TSB # 28-2019

TO: All Bourgault Dealers
ATTN: Service Manager, Parts Manager, Sales Manager
SUBJECT: Incorrect Geometry on X30/X35 Monitors.

INFORMATION BULLETIN

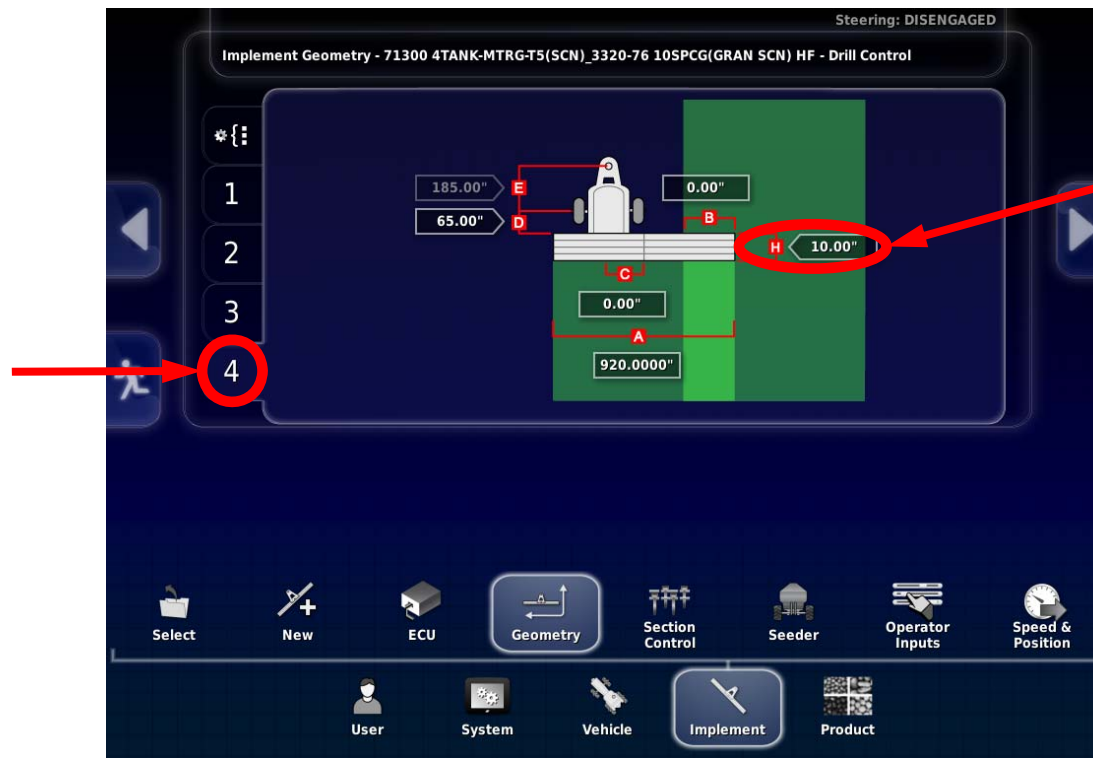
It has been discovered that the geometry in some of the factory profiles are incorrect. When the dual boom ASC software was developed for use in X30 and X35 monitors a mistake was made when creating the Drill Control geometry. This error will result in LIFTMASTER beginning to raise the openers too early – depending on seeding speed approximately 8-10ft.

DUAL BOOM PROFILES: Have an error in the 'Drill Control' Boom (Boom # 4)

DIMENSION H (Working Length)
- is set at a value of 10.00" in the factory profiles.

- Follow the instructions on page 2 to correct the geometry.
